NEI 13-02 [Rev. ~~G2-1D12~~]

INDUSTRY GUIDANCE FOR COMPLIANCE WITH ORDER EA-13-109

**BWR Mark I & II Reliable Hardened
Containment Vents Capable of Operation
Under Severe Accident Conditions**

~~September-October~~ 2013

Figure 2-1

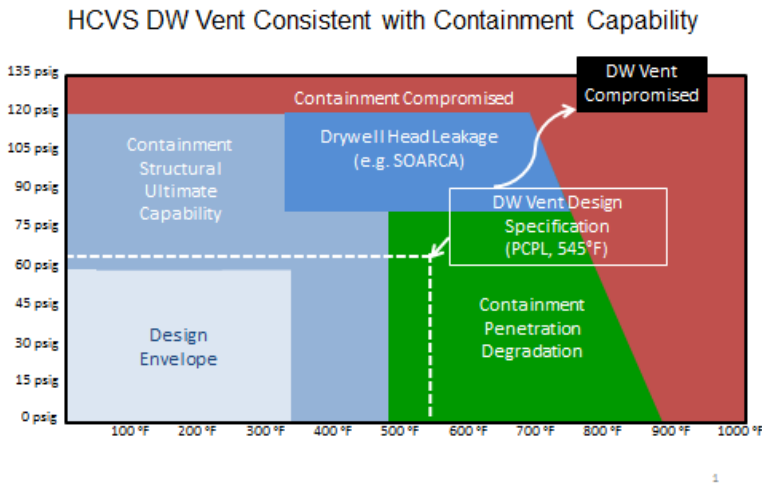
2.4.4.2. As pictorialized in Figure 2-1, which demonstrates the representative margin of the containment based on the design envelope, extending the DW HCVS vent design values to PCPL and 545°F will provide an assurance that margin is maintained in the DW head region by selecting this design point for the DW vent.

Selection of this design point (PCPL and 545F) should provide margin to avoid gross drywell head seal leakage.
